**FINAL DRAINAGE REPORT
FOR
WOODMEN HILLS METROPOLITAN DISTRICT
WEST WATER TANK**

WOODMEN HILLS METROPOLITAN DISTRICT
 WEST CONCRETE WATER STORAGE TANK
 SITE DEVELOPMENT PLAN
 DETENTION POND OUTLET PLAN & PROFILE

PCD File No. PPR-20-017

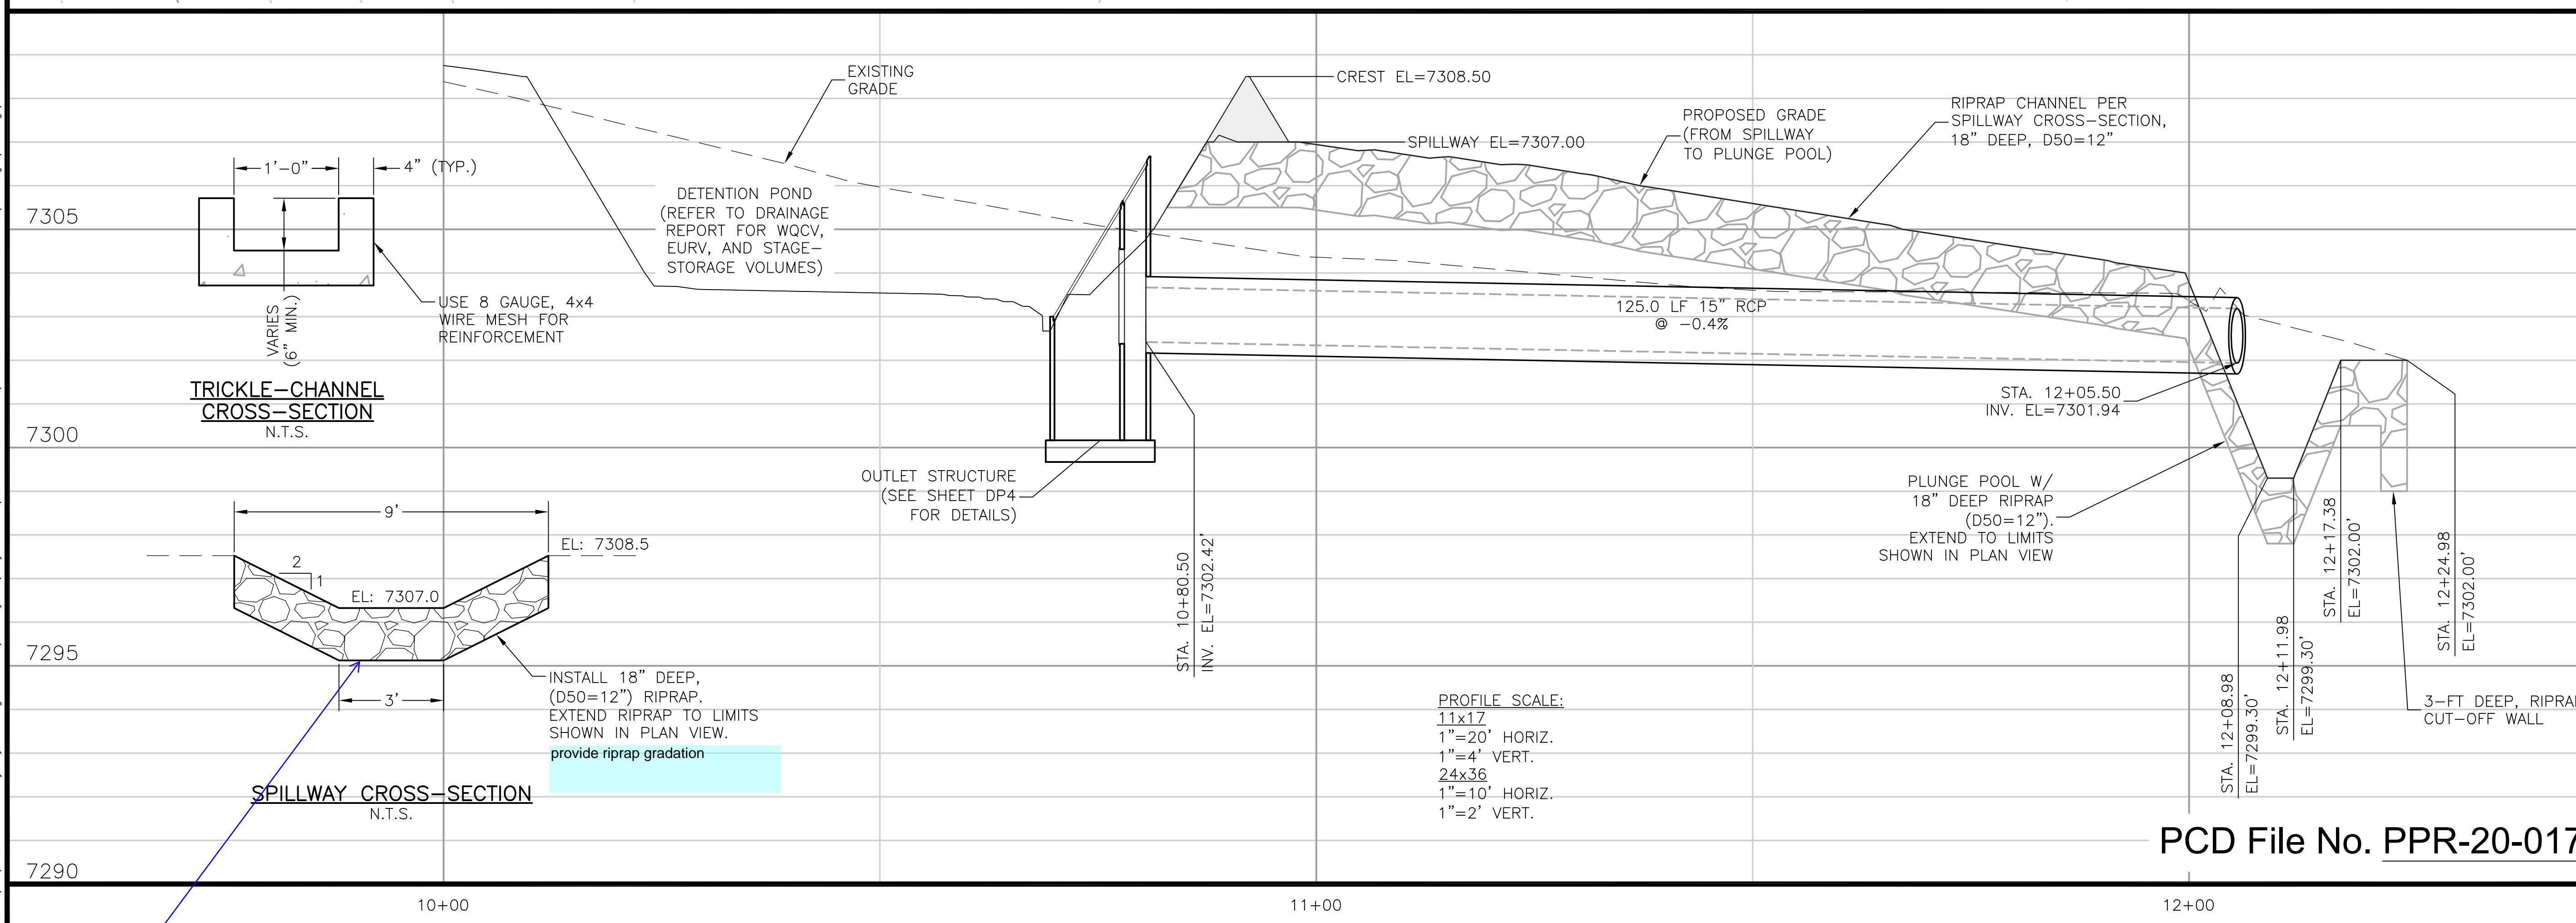
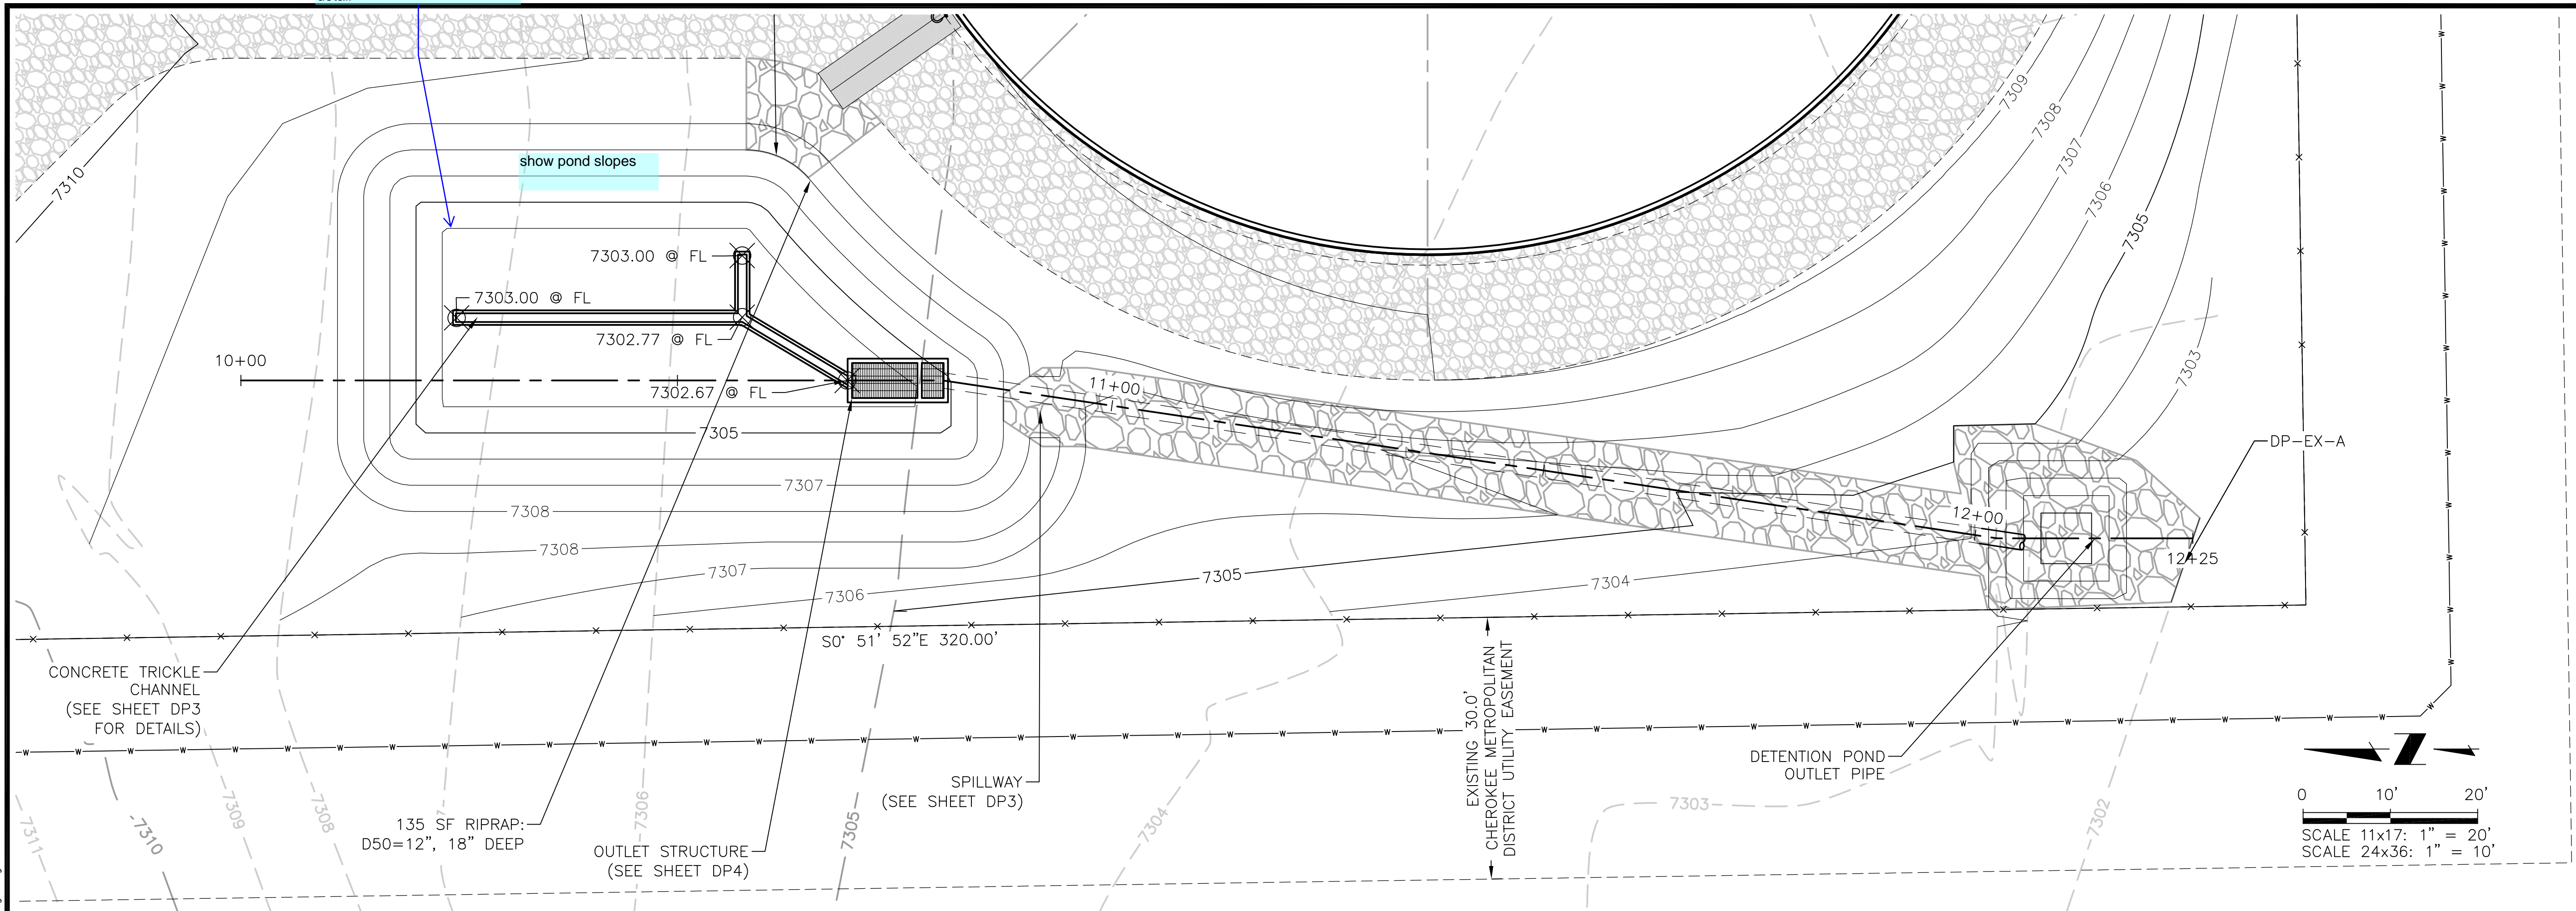
include maintenance access roadway & provide construction detail

provide bedding material and/or geotextile fabric between riprap and sub-base
